BZA2004-00085

| SIGN TYPE: Pole Sign | | | | | | | |

**Wichita-Sedgwick County Metropolitan Area Planning Department**

**RE:** **BZA2004-00085: Sign Code Adjustment to increase the maximum allowed height of a ground sign to 20 feet above the height of the highway railing at a point perpendicular to the sign.**

# SITE PLAN

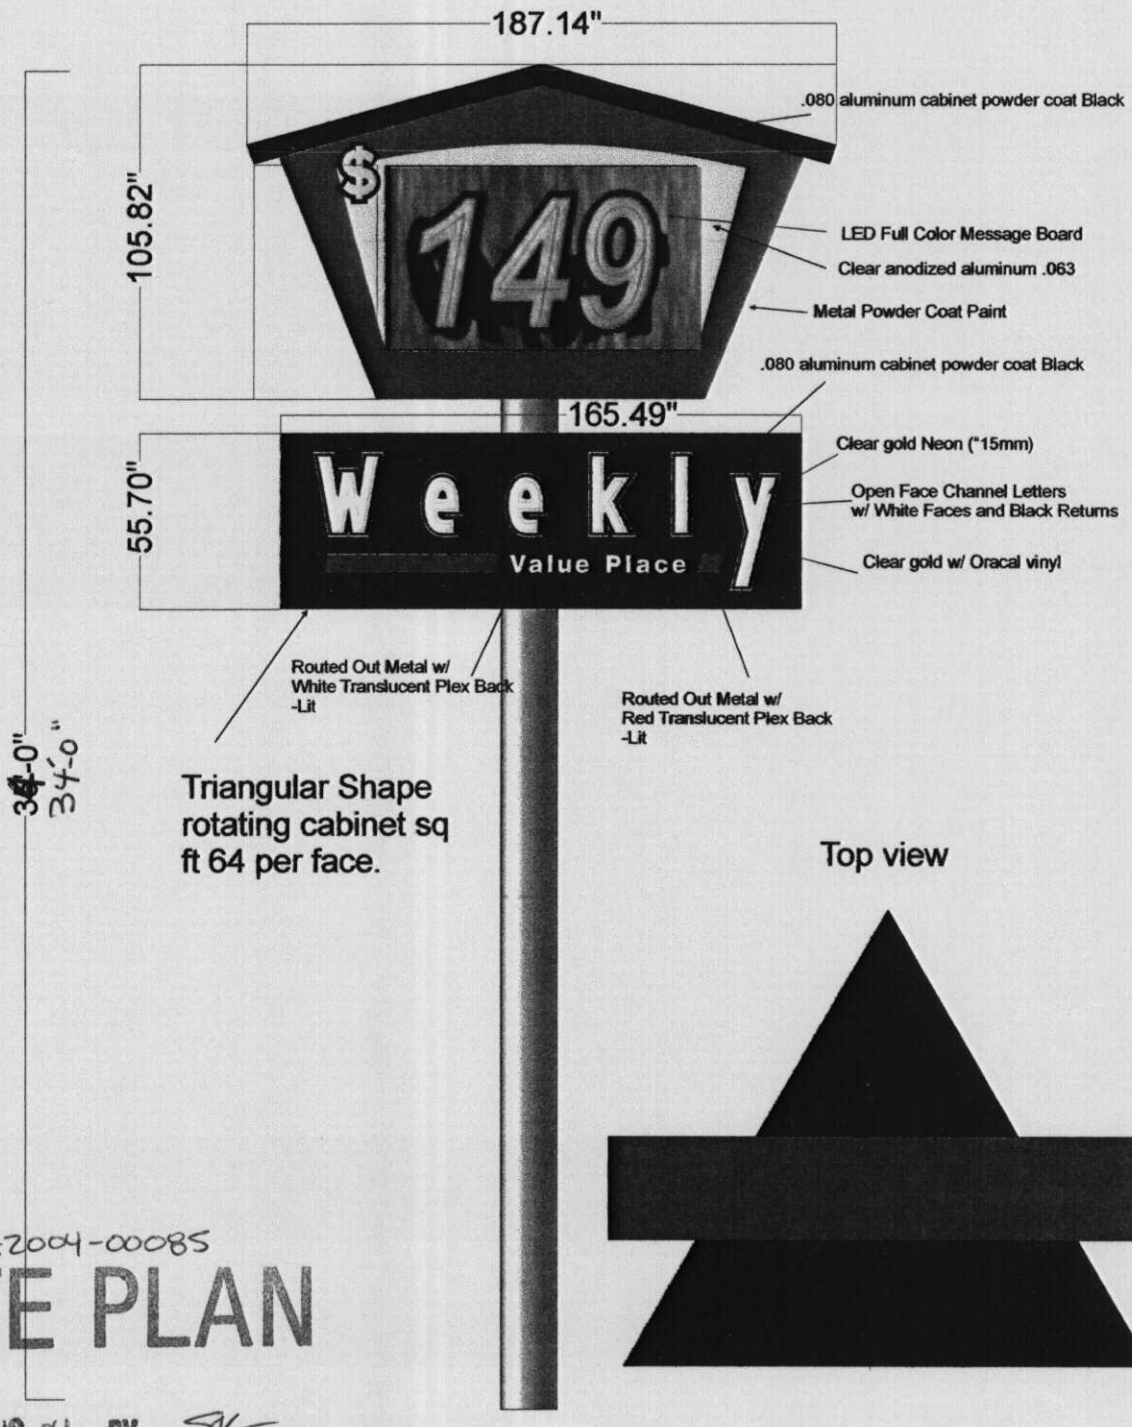
1) There shall be only one ground sign permitted along the subject property's K-96 frontage. Said sign shall be limited to a maximum height of 34 feet and shall generally conform to the location and design of the approved site plan and elevation drawing.
